PROPOSED SITE PLAN PORTSMOUTH MAPLE MASJID 686 MAPLEWOOD AVENUE

PORTSMOUTH, NEW HAMPSHIRE
PERMIT PLAN

PLAN SET SUBMITTAL DATE: 19 MARCH 2019

SITE PLAN

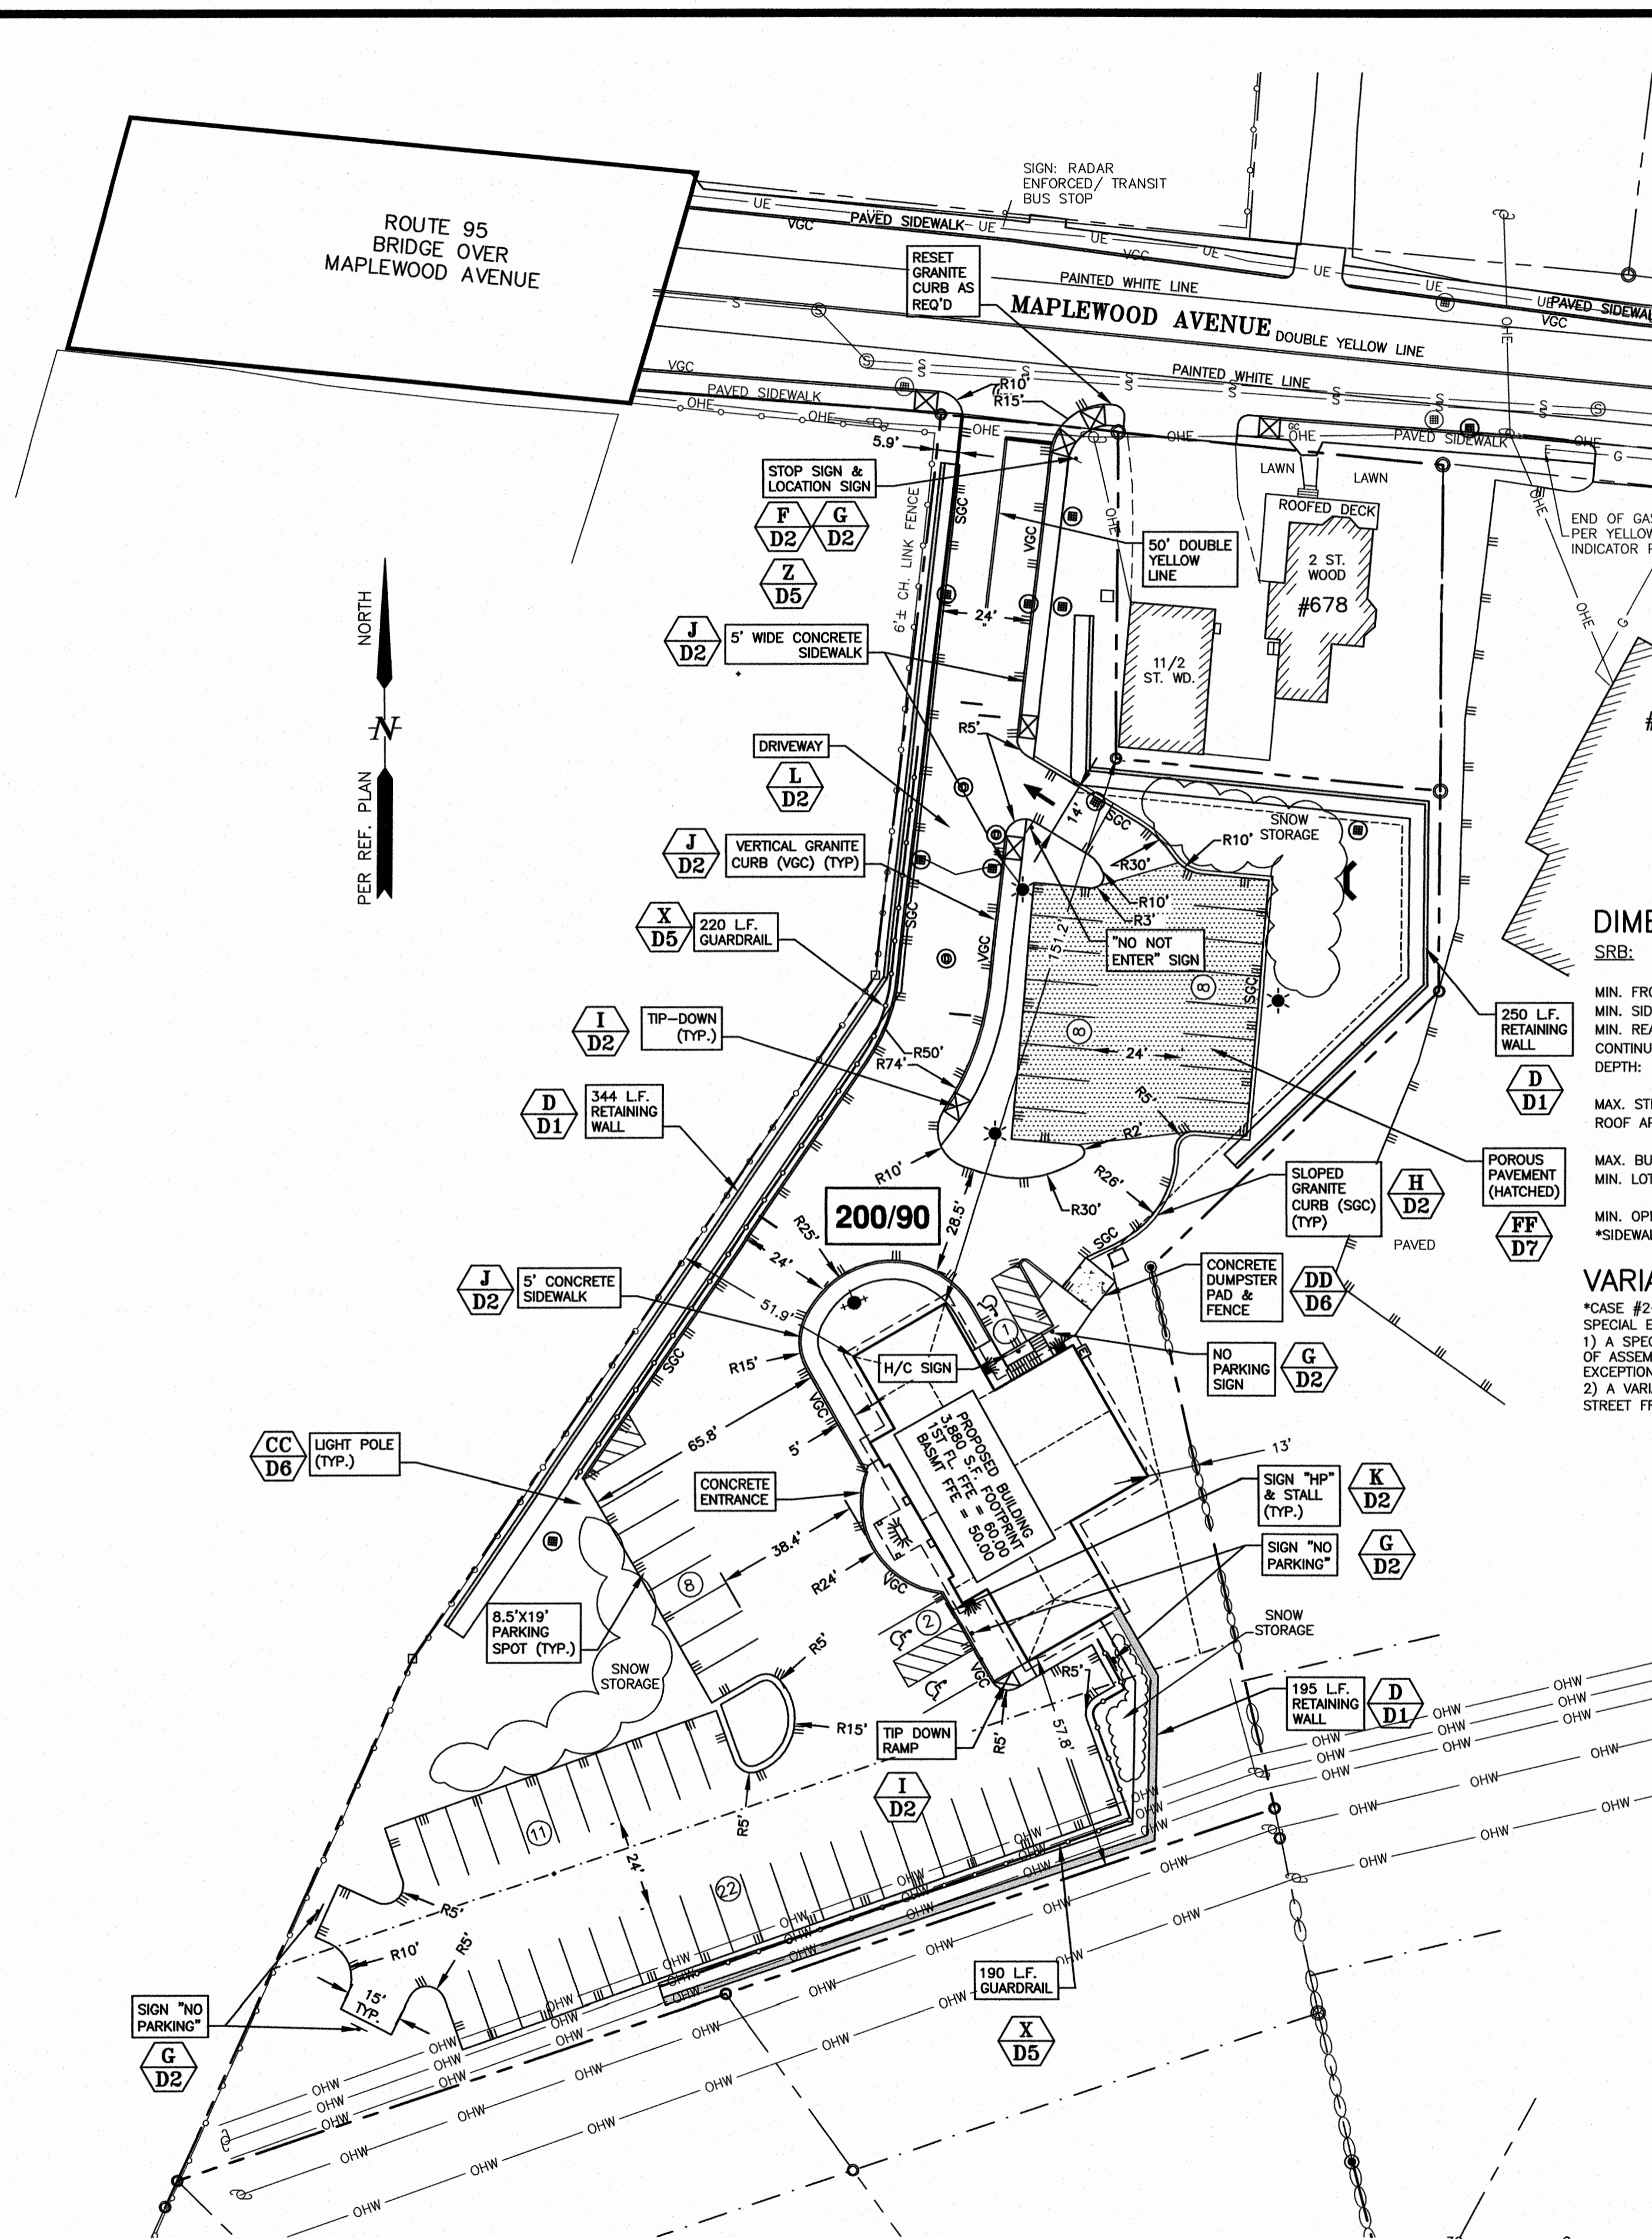
The snow storage areas shown on the Site Plans (sheet C2) are upgradient from the filtration basins; however, we question whether the areas shown are adequate. If these areas are inadequate, it is likely snow will be pushed into the filtration basins. **We have added a snow storage area to the east of the building. Note #8 on sheet C2 states “Excess snow shall be trucked from site.”**

HH C4 WALL SECTION & FILTRATION BASIN PS1a NTS
 NOTE: PROVIDE STAMPED WALL DRAWINGS TO BUILDING INSPECTION DEPARTMENT FOR REVIEW AND APPROVAL PRIOR TO CONSTRUCTION.

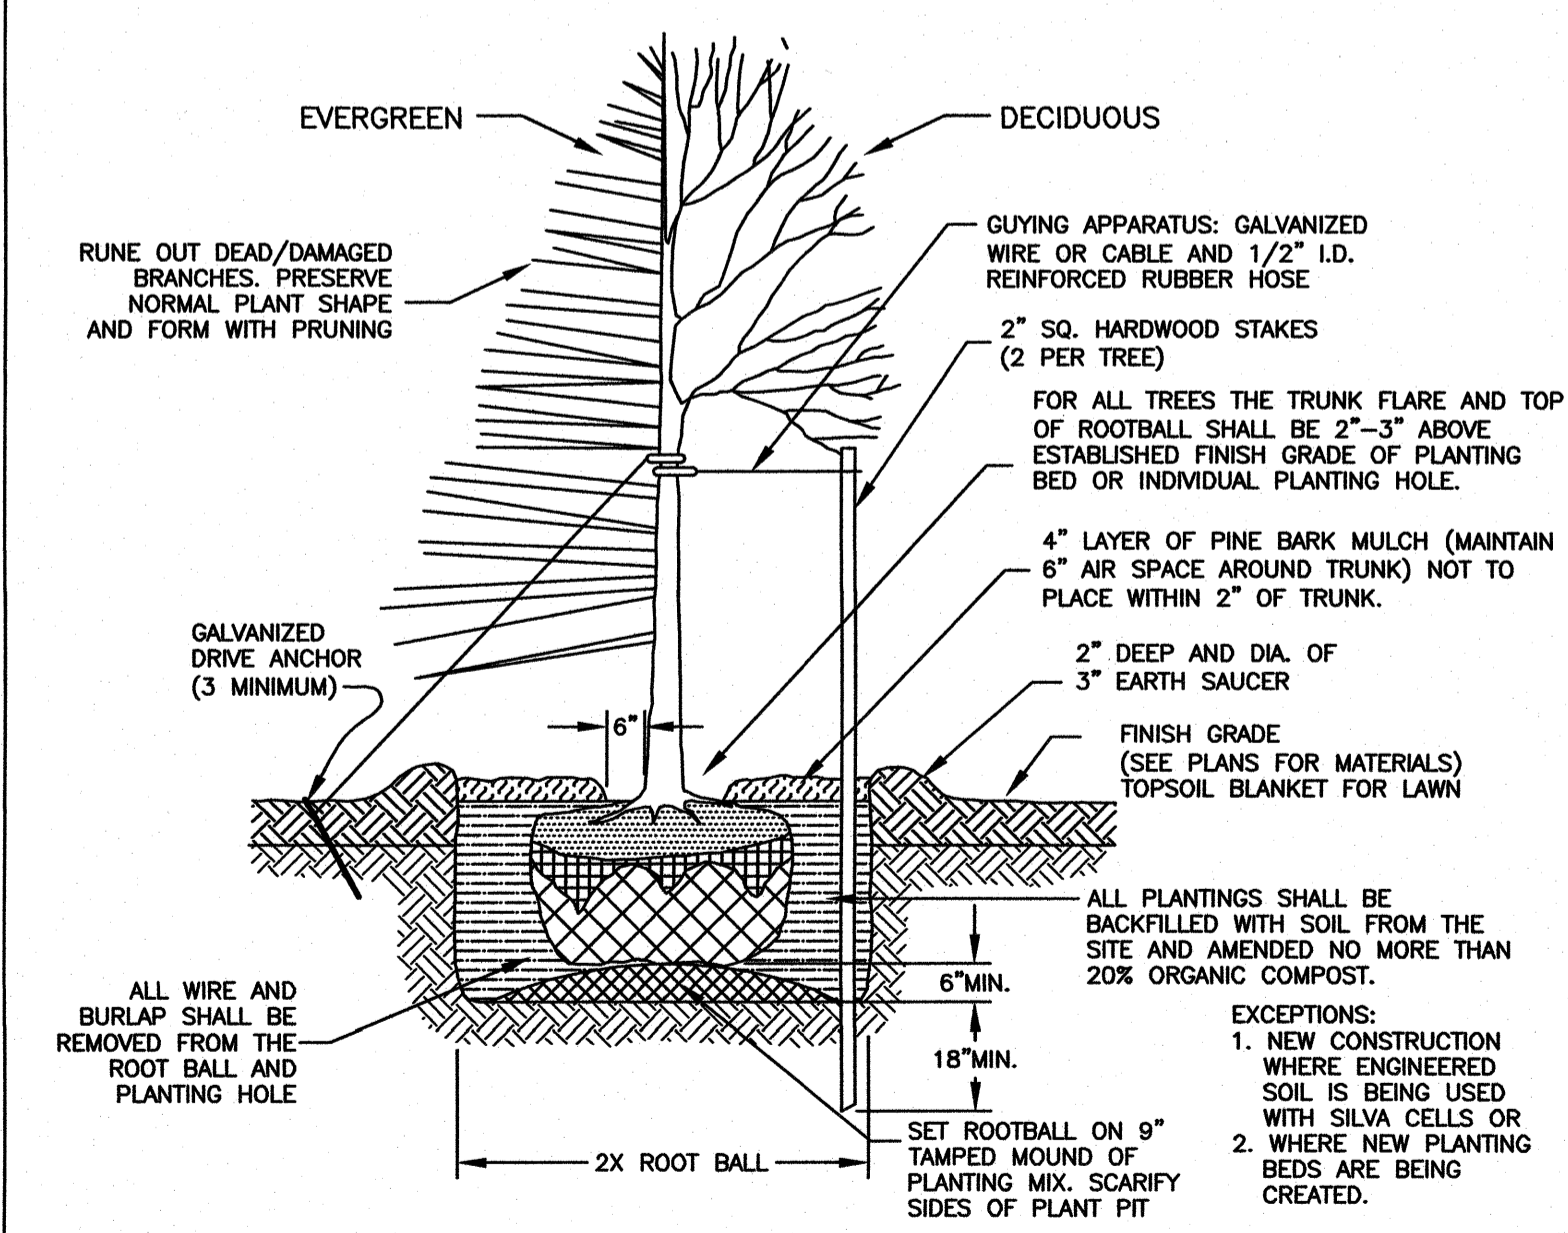
4. Detail D on sheet D1 is inadequate. The intent is to show how the stormwater pond will be constructed to prevent ponded water from leaking down and blowing out the wall. **Detail HH on sheet D& has been added showing a 30 Mil impermeable liner that removes water from the area before it gets to the wall.**

FIRST FLOOR PLAN
1/4" = 1'-0"

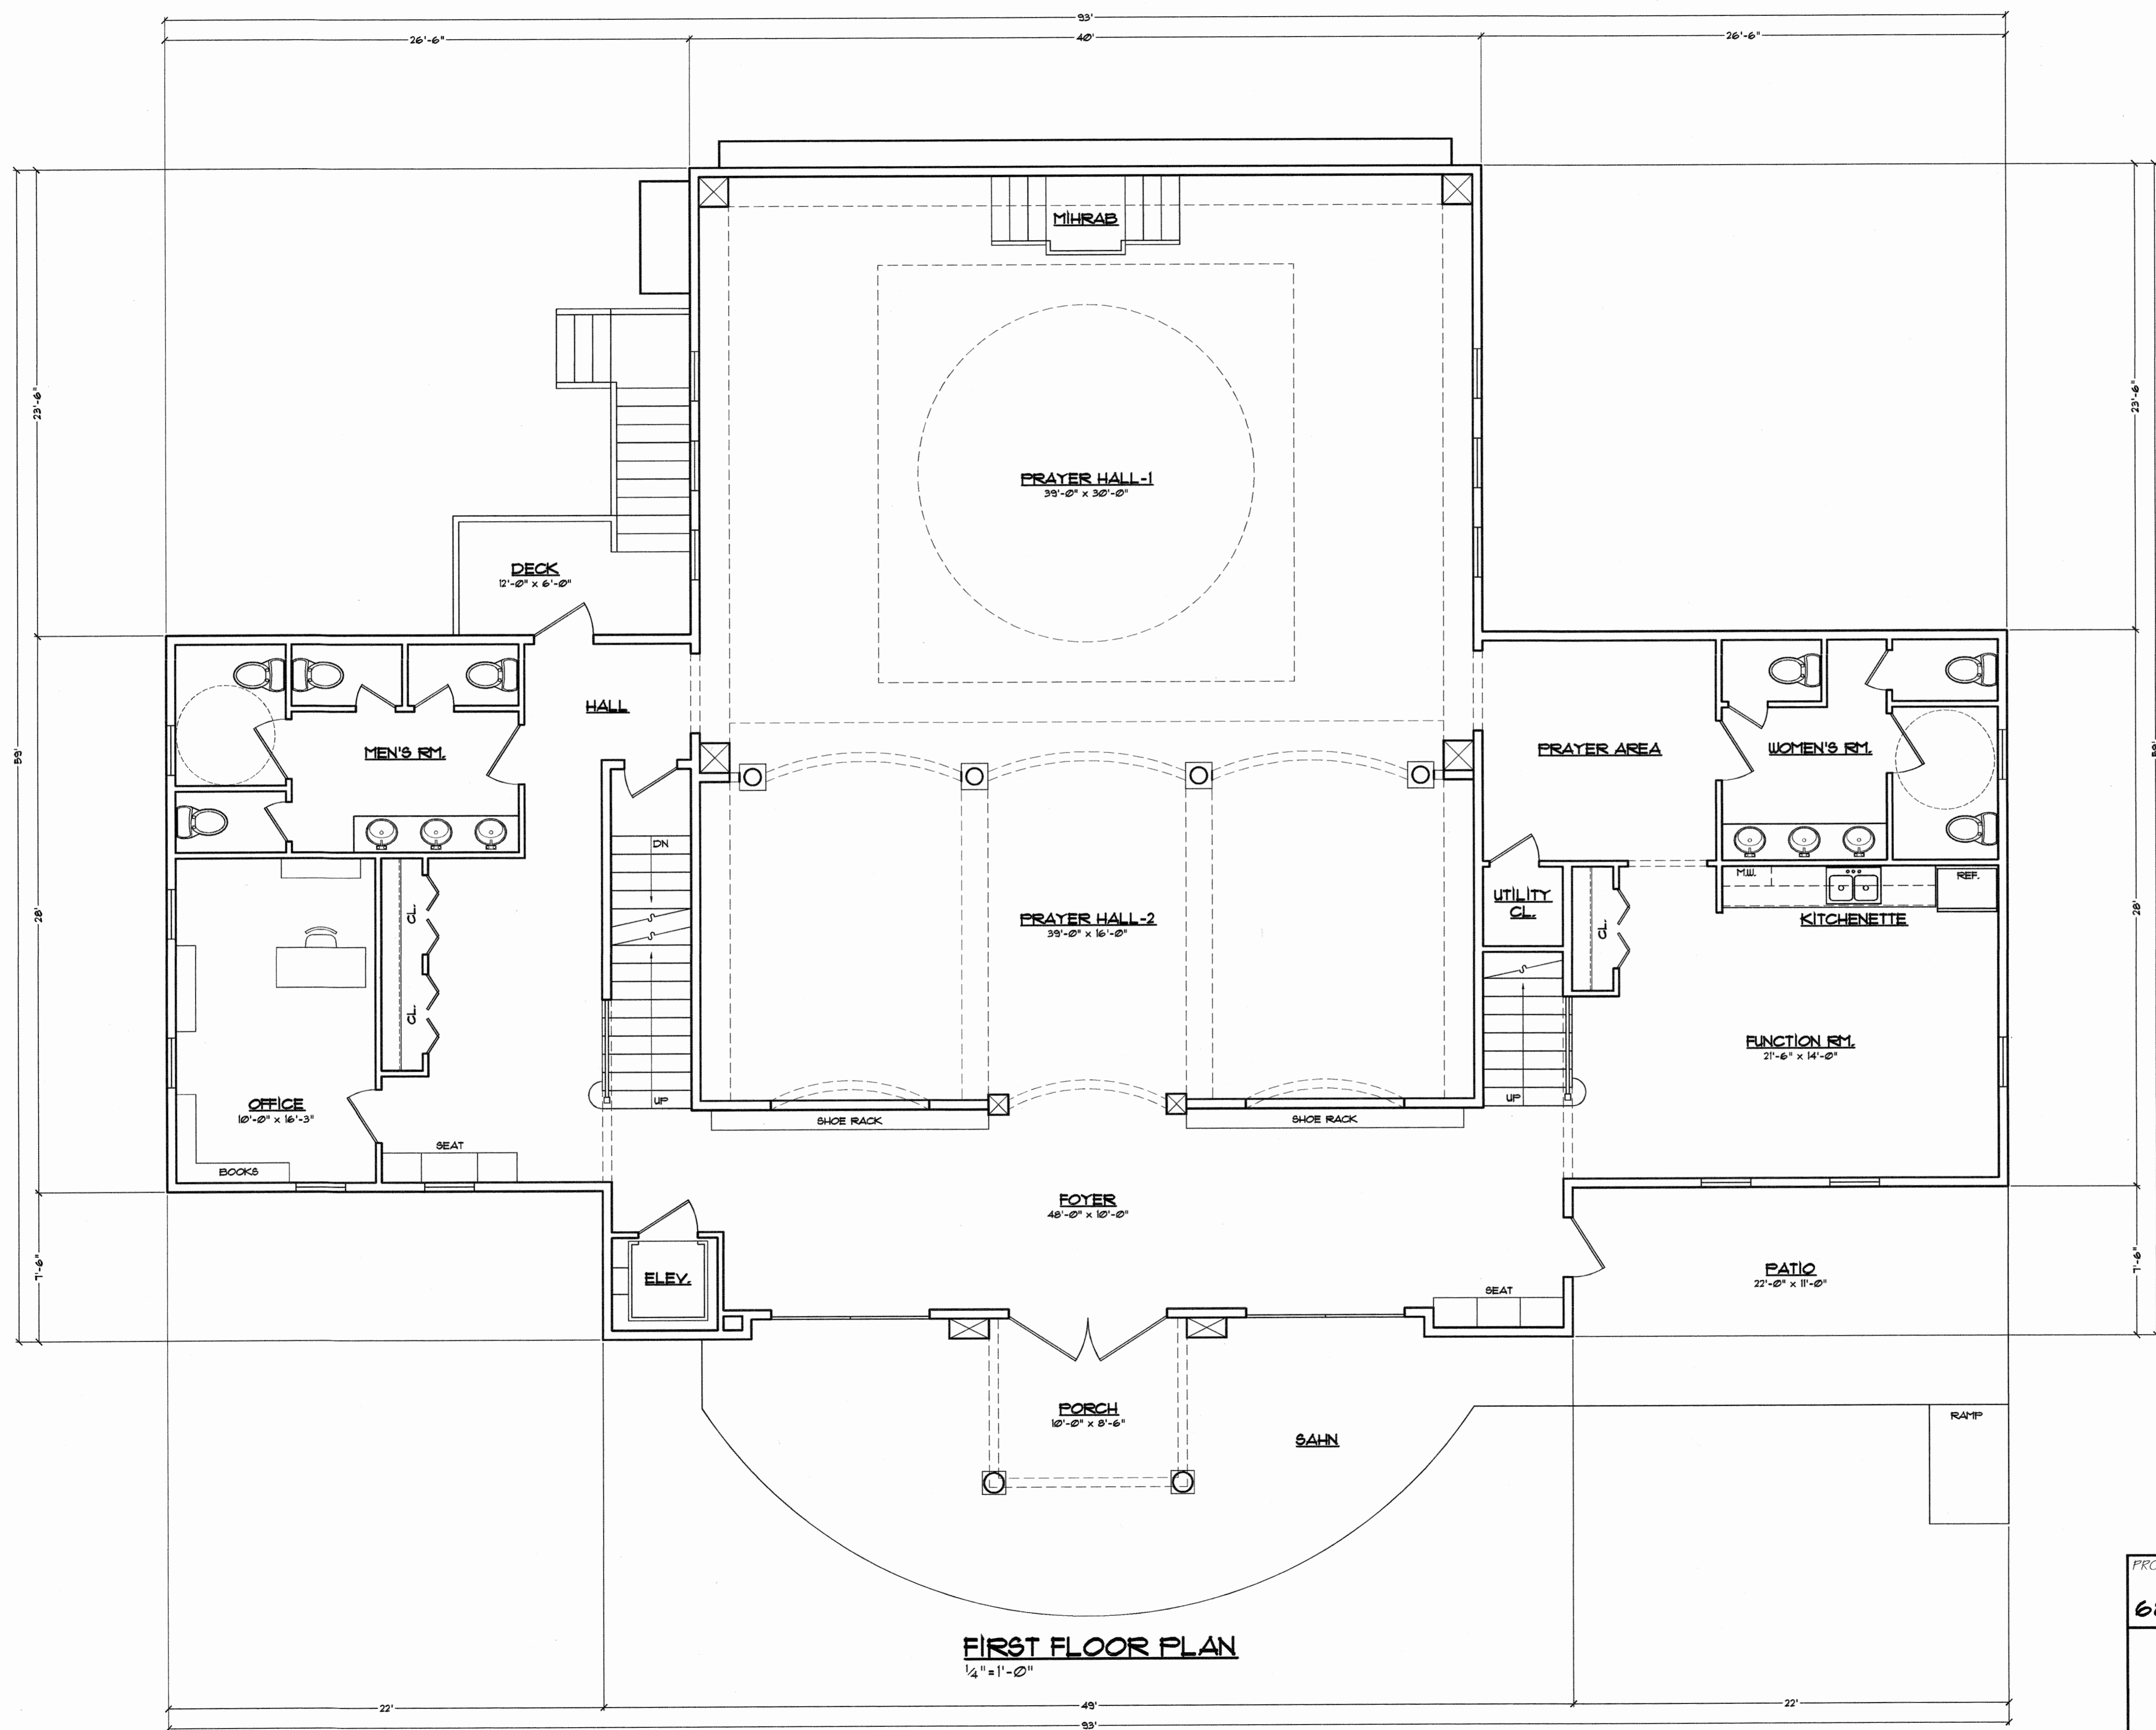
6. **1st Floor** The floor plans do not show a drinking fountain or service sink; however, both are required by the NHSPC §403.1. The plans should be modified accordingly to include a service sink and an accessible drinking fountain. Per the requirements of ICC ANSI A117.1 and the ADAS an accessible drinking fountain should include a double bowl providing a high and low height spout. In addition, the fountain should be installed in a niche or similar wall recess so that the fountain does not create an excessive projection along an egress route. Use of the Kitchenette sink, water cooler or other alternative means for drinking water must be reviewed and approved by the AHJ and is required to be accessible.
